Docket Item # 1
BAR CASE #2016-00014

BAR Meeting
February 17, 2016

ISSUE: Certificate of Appropriateness - Alterations

LOCATION: 102 Prince Street

EXISTING FRONT ELEVATION

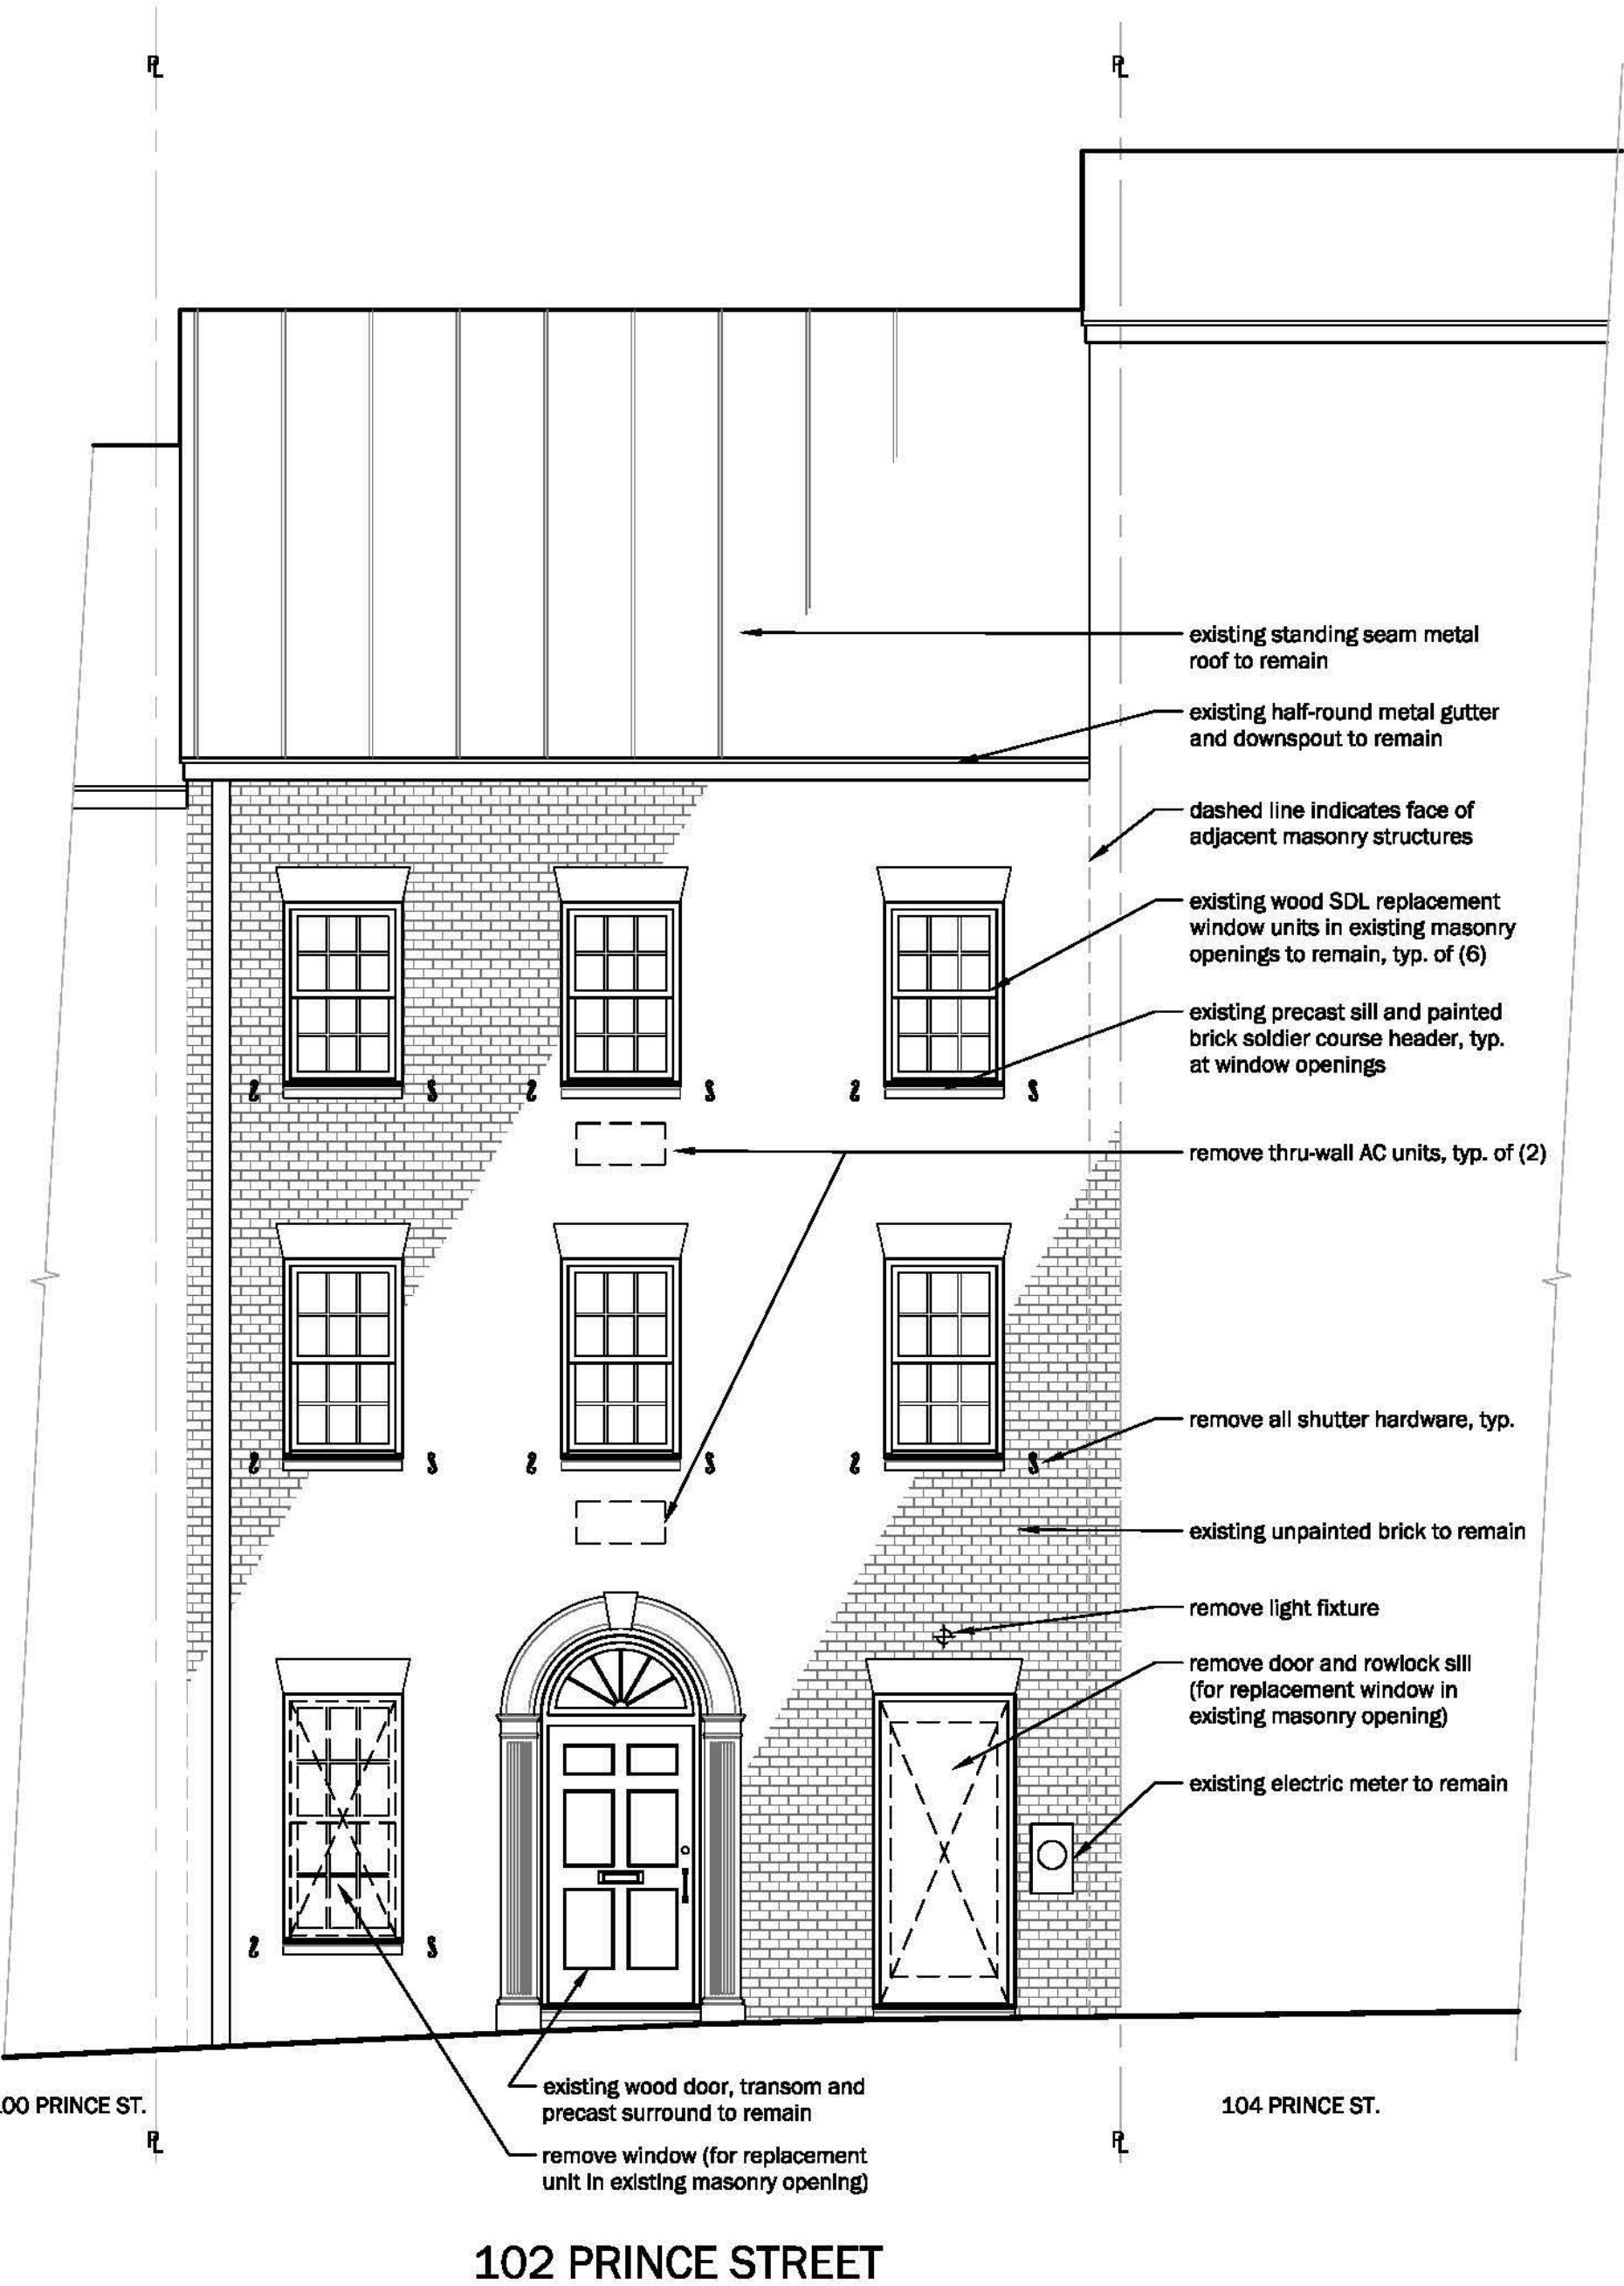
Although staff is not able to determine from site visits or research whether the secondary entry door was included in the original design approved by the BAR in 1971 or was a later addition, staff does not object to its replacement with a new window, as it will enable a more balanced façade composition, in keeping with the symmetrical architectural style of the building. Staff strongly supports removal of the thru-wall air conditioners and repair of these openings with matching brick. Additionally, staff finds that replacement of the existing first floor windows on this post-1965 dwelling with aluminum-clad wood windows comply with the BAR's replacement *Window Policy* and, as previously noted, these could have been approved administratively.

However, staff recommends that, if shutters are to be installed, that they replace the previous shutters on all three levels and that the shutter on the west side of the first floor window be included, as well. It was not uncommon for historic shutters to conflict with architectural features and to be partially held away from the wall. Staff has no concern with the shutter lying against the electrical meter in this case.

Staff recommends that the Board approve the Certificate of Appropriateness application with the conditions that:

1. The shutters may be either wood or a paintable, millable, solid composite material; and
2. That the shutters be installed on all openings on the front façade.

PROPOSED FRONT ELEVATION

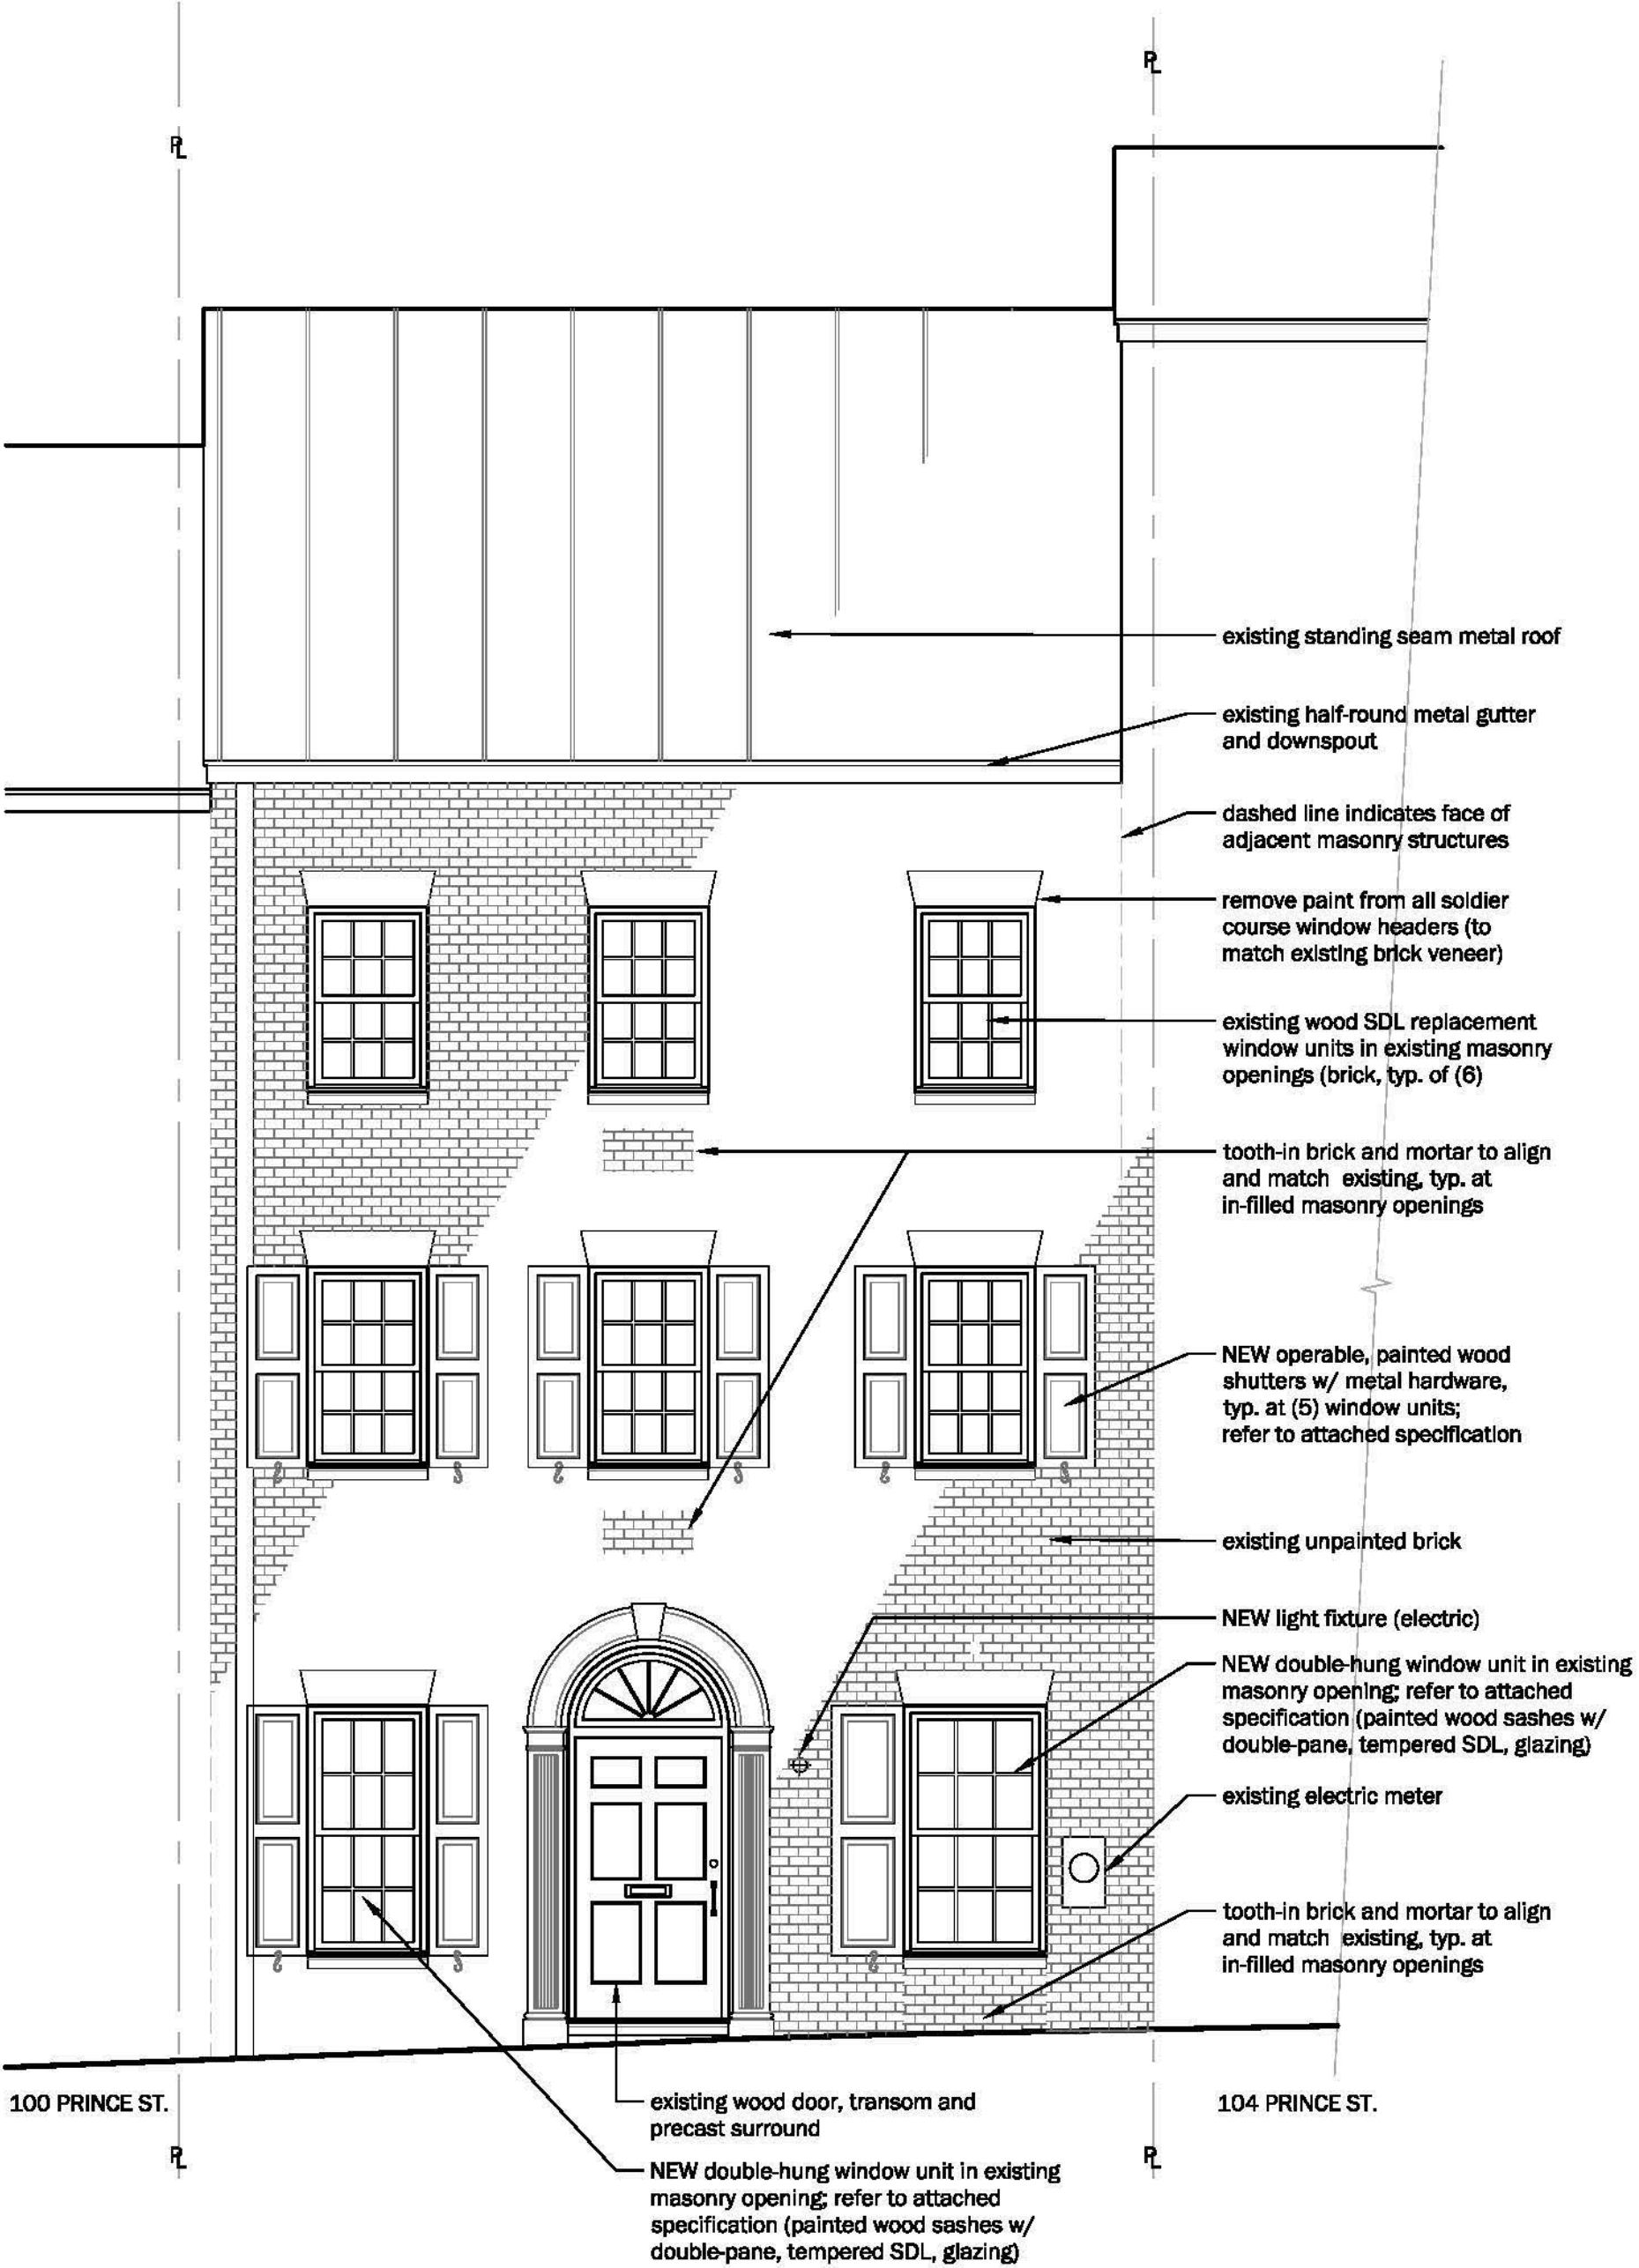
Regarding the installation of shutters, staff supports their reinstallation as the shutter hardware remains on the building. Although the applicant is electing to use a painted wood, two-paneled shutters, staff notes that the Board has previously approved painted, solid composite shutters in similar situations, including a historic building a couple of doors down from this property, and composite shutters are administratively approvable on buildings constructed after 1970. These composite shutters are not to be confused with the hollow vacuum formed vinyl shutters commonly screwed to the wall of suburban dwellings. High quality, solid composite shutters are constructed with multiple pieces joined the same way as wood shutters and are often more expensive than wood but require less maintenance than most modern wood shutters and, once painted, are visually indistinguishable from wood. Staff recommends that the Board approve either painted wood or wood composite shutters, at the applicant's option.
